Review of Carbon Review of Carbon TerraVault (CTV) Responses to EPA's Questions about Proposed Testing and Monitoring Activities at the A1-A2 Class VI Project

In January 2022, EPA provided questions to CTV (*blue, italic text*) about proposed injection and post-injection monitoring activities submitted with CTV's Class VI permit application (dated August 30, 2021) for the proposed Carbon TerraVault (CTV)-Elk Hills Class VI geologic sequestration (GS) project. CTV provided an updated Testing and Monitoring Plan and PISC and Site Closure Plan to EPA on March 31, 2022. EPA's evaluation of how the updated plans address its questions is presented in **red** below. Requests for revisions and additional information are presented in **red, bold, and italic** below. Previous responses that require no further information are not included in this enclosure.

Figure 2 of the QASP shows the locations of all monitoring wells associated with the project and is reproduced below.

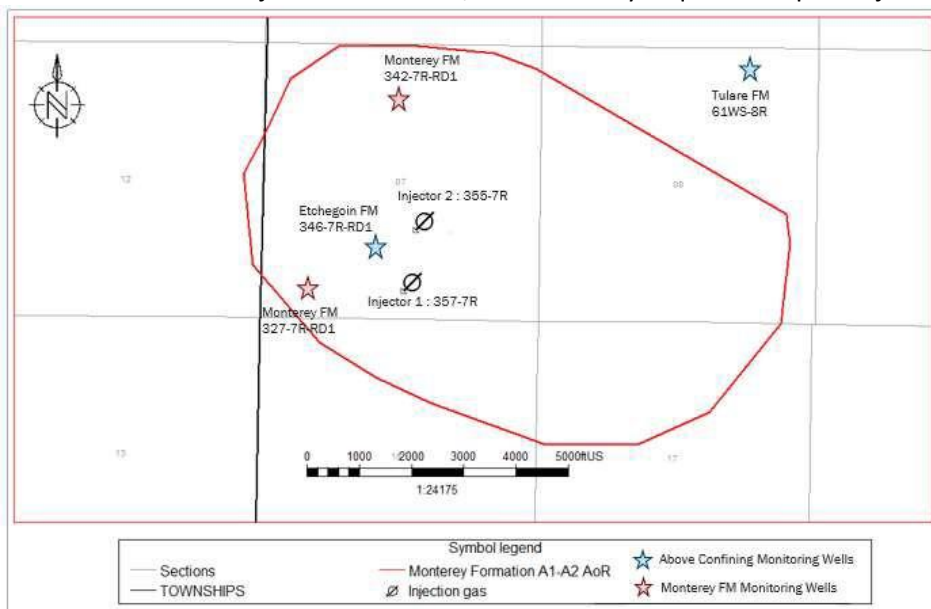
The Etchegoin Formation monitoring well appears to be situated within the AoR and in the anticipated path of the CO₂ plume and pressure front (based on information in Attachment B). The Upper/Lower Tulare Formation monitoring well is outside of the delineated AoR to the northeast of the injection

wells, and down plume. Given that the Tulare Formation does not hold much water within the AoR, this location, while not in the same direction as the deeper monitoring wells may be most appropriate to allow geochemical sampling, although it is unlikely that CO₂ will travel that far down the limb of the anticline. CTV states that additional Upper Tulare monitoring wells will be drilled if increased pressure is observed in the Etchegoin Formation monitoring well or water quality changes in the Tulare Formation that is due to Monterey Formation A1-A2 CO₂ injection. However, it is unclear how a linkage of water quality/pressure changes to CO₂ injection (and not other activities) would be made.

- *Please include the groundwater monitoring well 61WS-8R in Figure 4 of the PISC and Site Closure Plan. This was not added to Figure 4 as requested.*

- **Why was dissolved methane removed as a ground water analytical parameter?**
- **Please include well 61WS-8R in Figure 4 of the PISC and Site Closure Plan.**
